Open button operation - modification to improve reliability.

SUBJECT: Potential flickering problems

No. : TB-M1309101

Photo 1

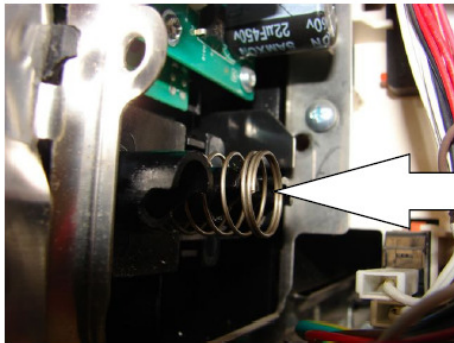
The compression spring that is currently fitted to the above models is to be removed and a torsion spring fitted to the open lever instead.

Remove Compression Spring (No longer required)

Photo 2

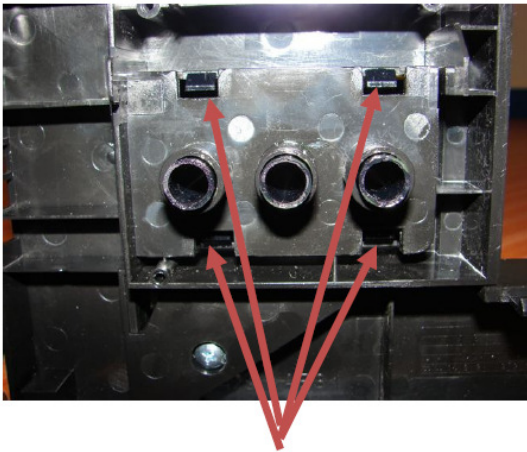
To remove the open button press in the X 4 location lugs as highlighted in photo 2 and photo 3 above. Then push out the button.

Photo 5

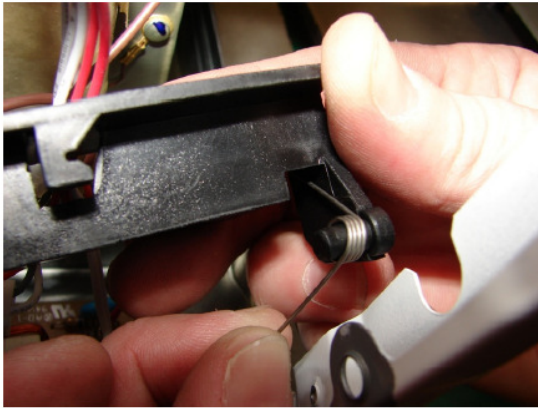
Remove the open lever from the cavity face plate.
 Place the torsion spring onto the post of the open lever and ensure the arm of the spring is located into the recess as shown. (Photo 5)
 Fit the open lever to the oven cavity, by inserting the posts of the lever through the location holes in the lower faceplate angle as shown. (Photo 6 & Photo 7)
 Check Spring is in place (Photo 8)
